GE Hitachi Nuclear Energy

MFN 07-305 Supplement 1

Subject: **Response to Portion of NRC Request for Additional Information Letter No. 96 Related to ESBWR Design Certification Application - Technical Specifications - RAI Number 16.2-119 S01**

RAI Numbers 16.2-119 S01

Figure 15.5-11a. MSIV Closure With Flux Scram

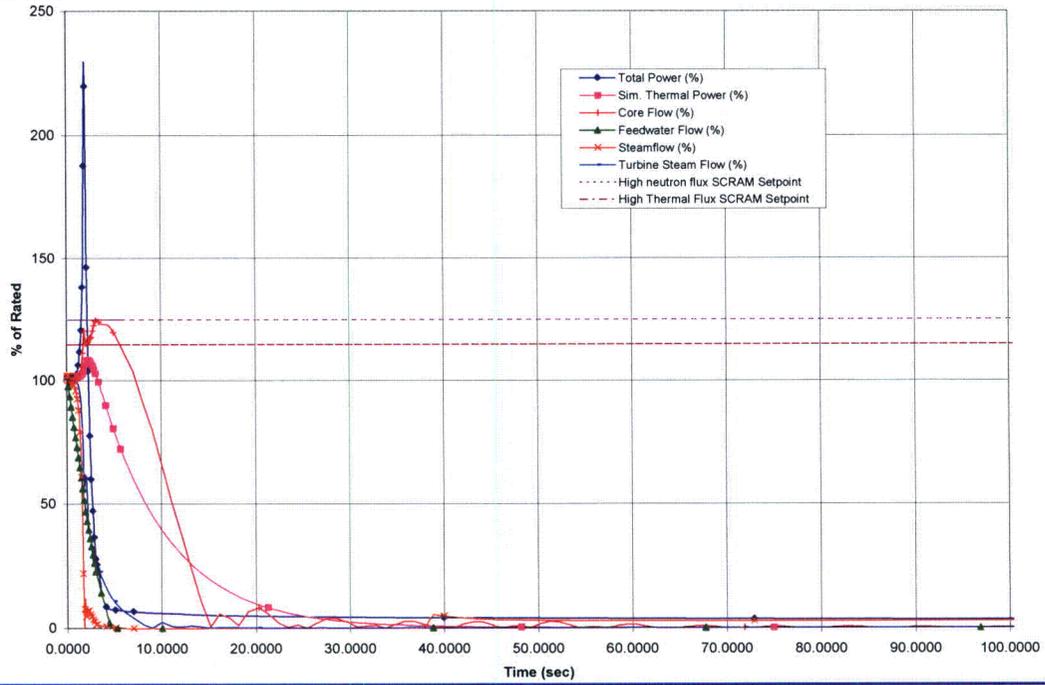
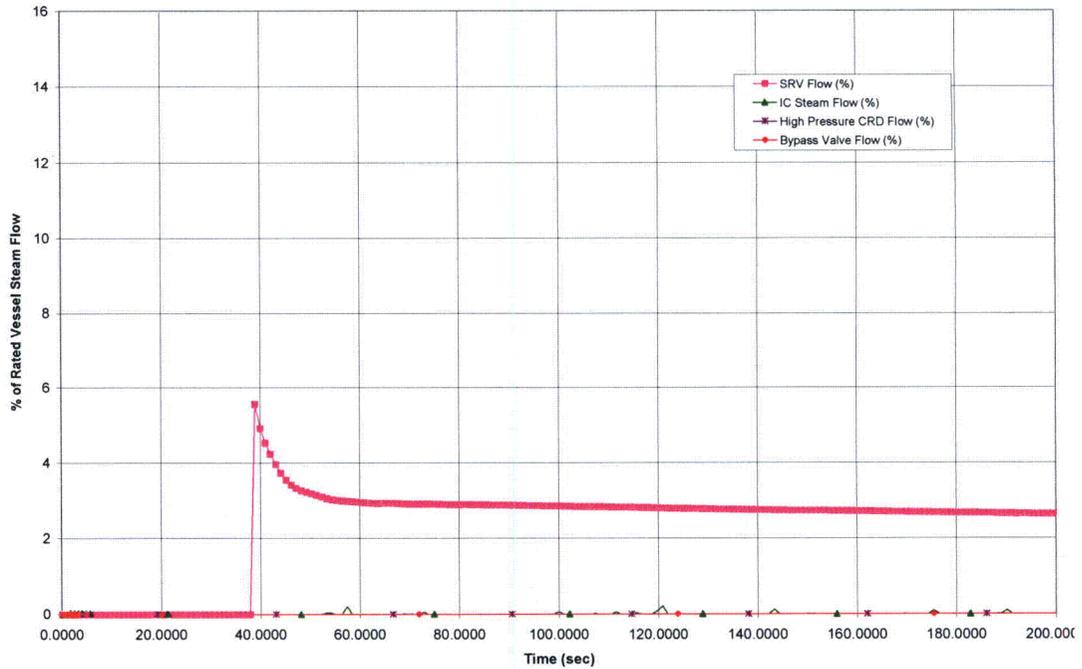
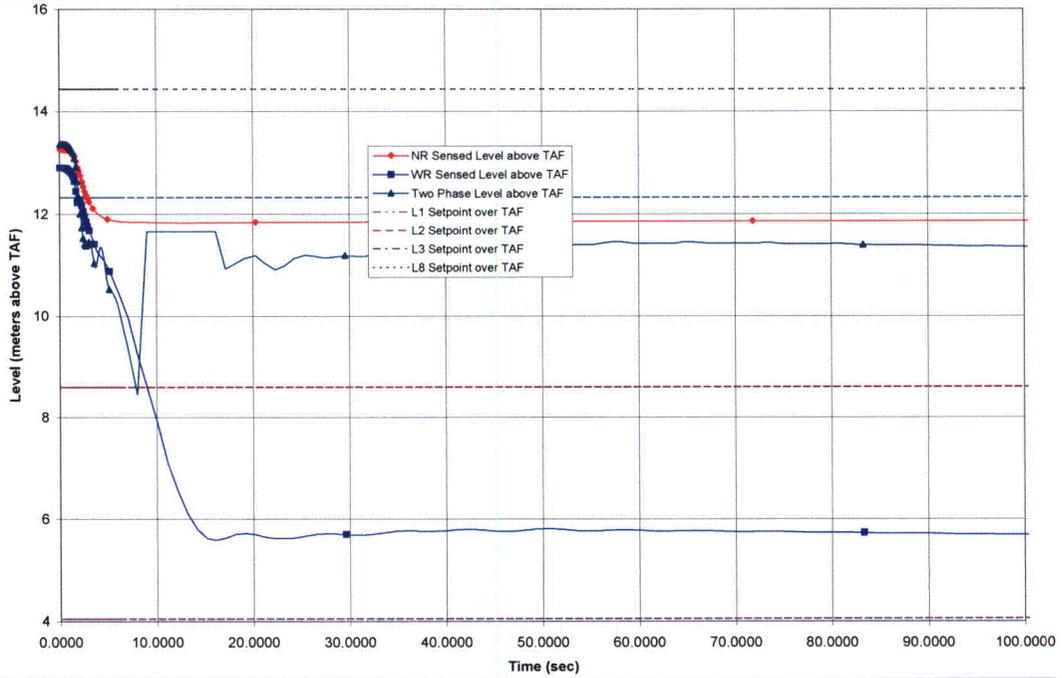
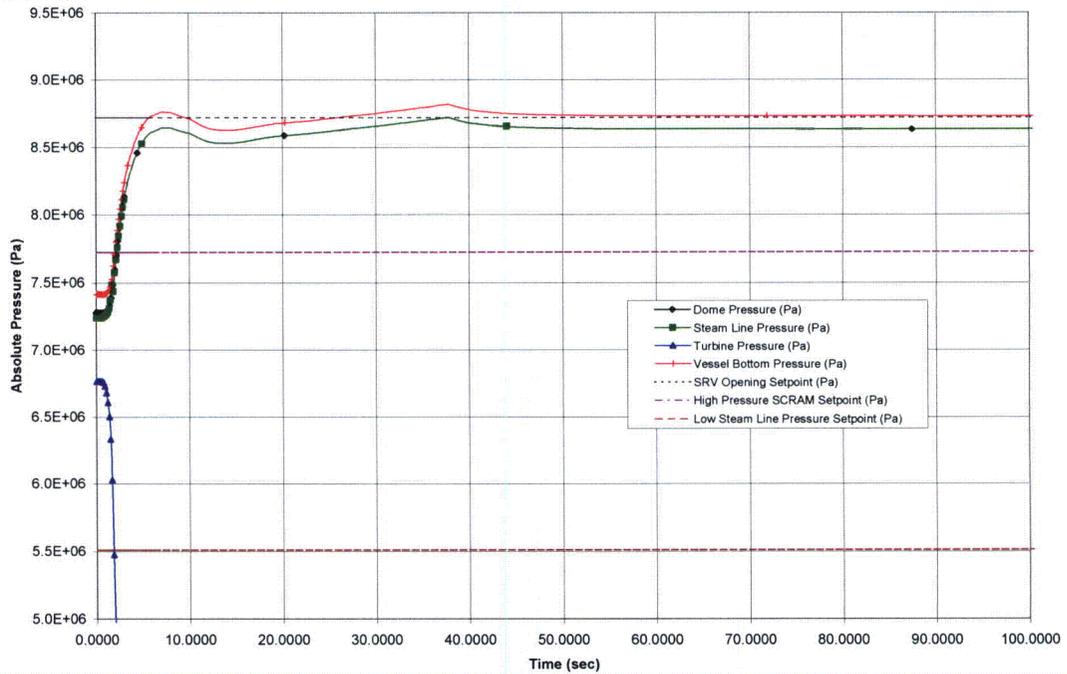
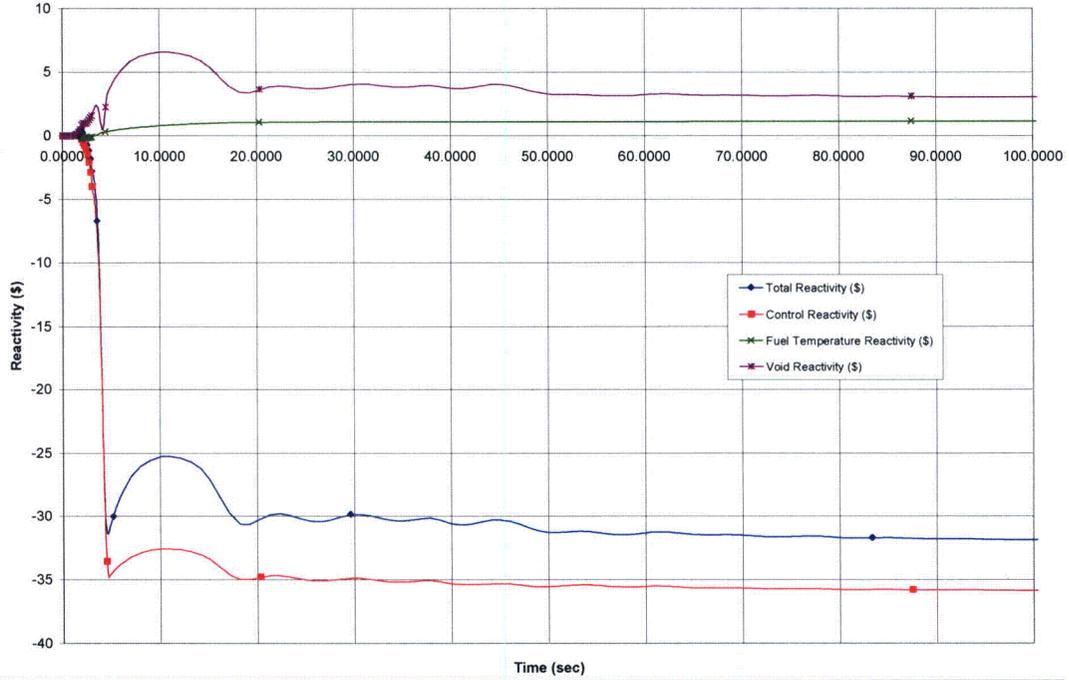
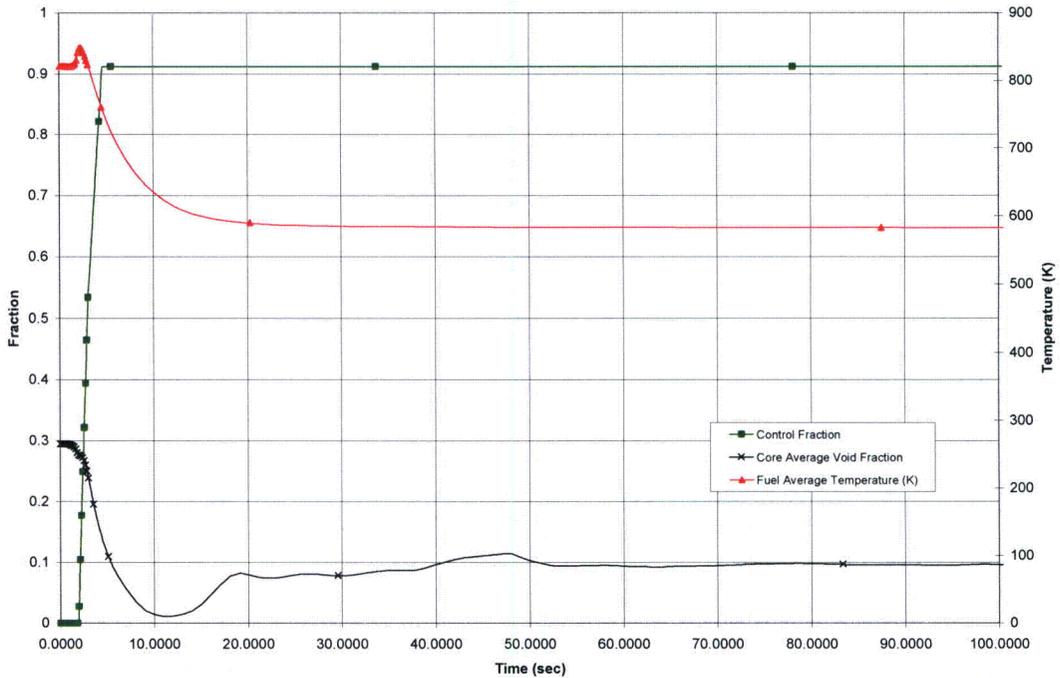
In the response to RAI 21.6-91 (MFN 07-256), GE states, "Changes to DCD Tier 2, Figure 5.2-4 will be made in response to this RAI. Figure 5.2-4 will be updated based on the result of a TRACG analysis that uses the following input files: MSIVF_EOC_NOFW.INP and SCRAM_PRESS_8GROUPS.TDT."

Since GE proposes to include only 1 SRV in the ESBWR Technical Specifications for overpressure protection, GE should verify that the input decks referenced above used to generate the Figures 5.2-4 in DCD Tier 2 only take credit for 1 SRV.

The TRACG analysis that credits the capacity of only 1 SRV for over pressure protection has been performed with the input file MSIVF_EOC_NOFW.INP and kinetics file SCRAM_PRESS_8GROUPS.TDT. The input file was modified to simulate the SRV capacity change from approximately 3 SRVs to that of 1 SRV: A replacement for Figure 5.2-4 has been generated for inclusion in the DCD, but has been changed to Figure 15.5-1 as the analysis for the MSIV closure with flux scram event is now described in section 15.5.1.1 of the DCD.

The analysis resulted in no change in the maximum reactor vessel pressure and demonstrates that 1 SRV is sufficient to mitigate the reactor vessel pressure response.

The adequacy of one SRV's capacity is demonstrated by analyzing the pressure rise from a MSIVF special event. Results of this analysis are given in Figure 15.5-11a through Figure 15.5-11f. Table 15.5-1b lists the sequence of events for Figure 15.5-11. The calculated peak vessel bottom pressure is less than the acceptance limit of 9.481 MPa gauge (1375 psig). The pressurization is not dynamic and does not significantly overshoot the relief valve setpoint. Vessel pressurization ceases to increase following a single relief valve opening when the steam discharge capacity exceeds the stored energy of the vessel plus rate of decay heat. The peak vessel pressure is only a function of the valve setpoint. This is because the higher steam volume-to-power ratio of the ESBWR causes the pressure rate prior to scram to be much lower than operating BWRs. After a scram, the pressure rates due to core decay energy release are correspondingly lower.
